Final Plat - Second Addition to Quarry Vista

City of Fitchburg

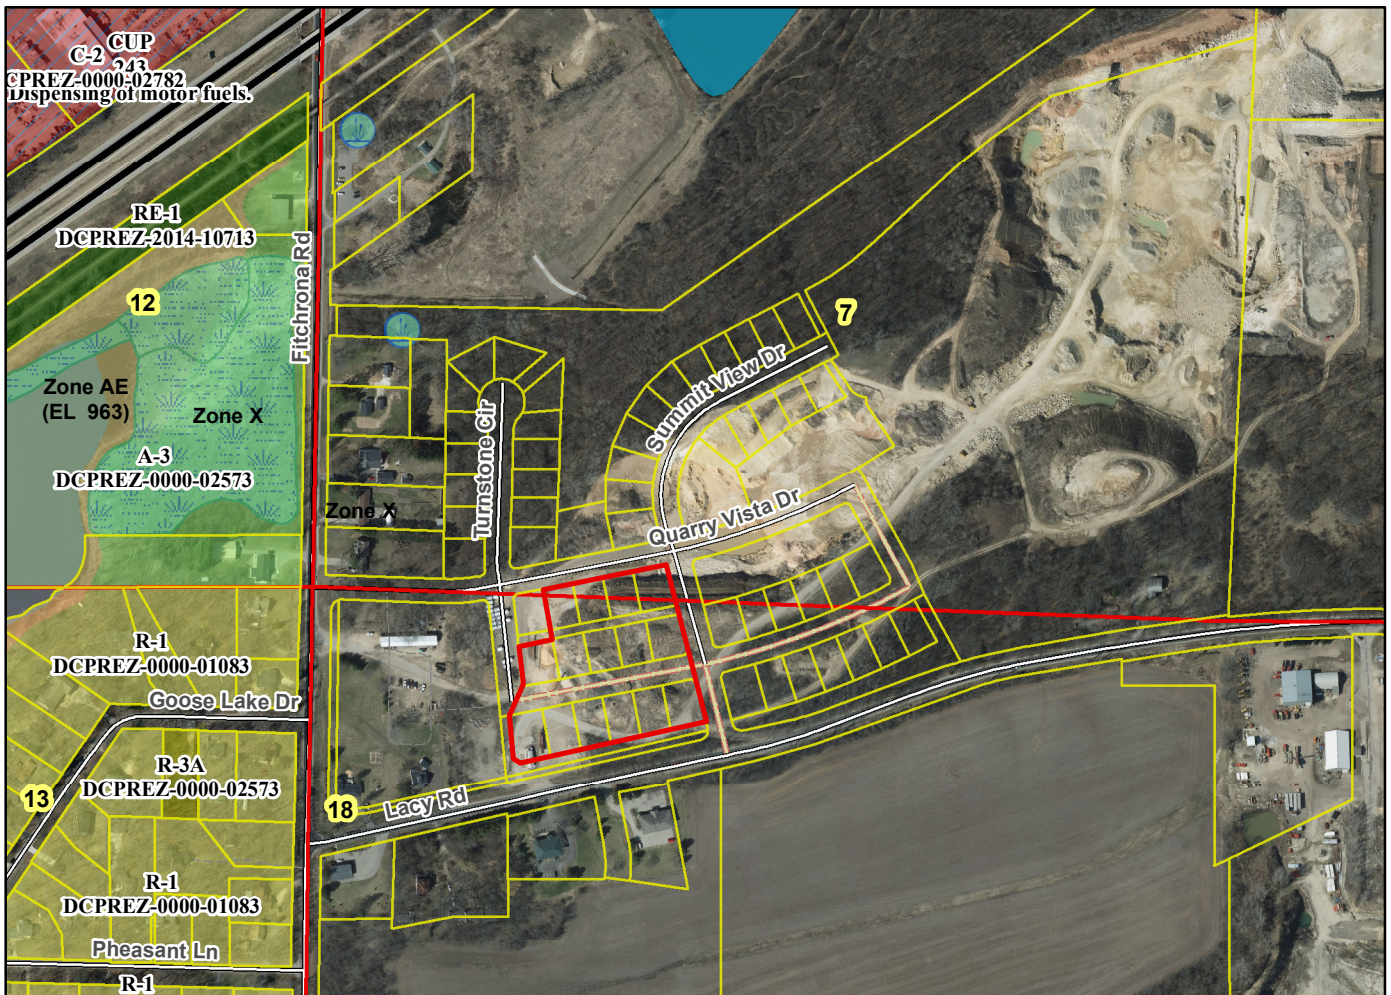
Parks - No parkland shown.

Parkways - none

Expressways - N/A

Major Highways - USH 151 to the north.

Airports - Dane County Regional

Drainage Channels - Drainage arrows shown.

Schools - established
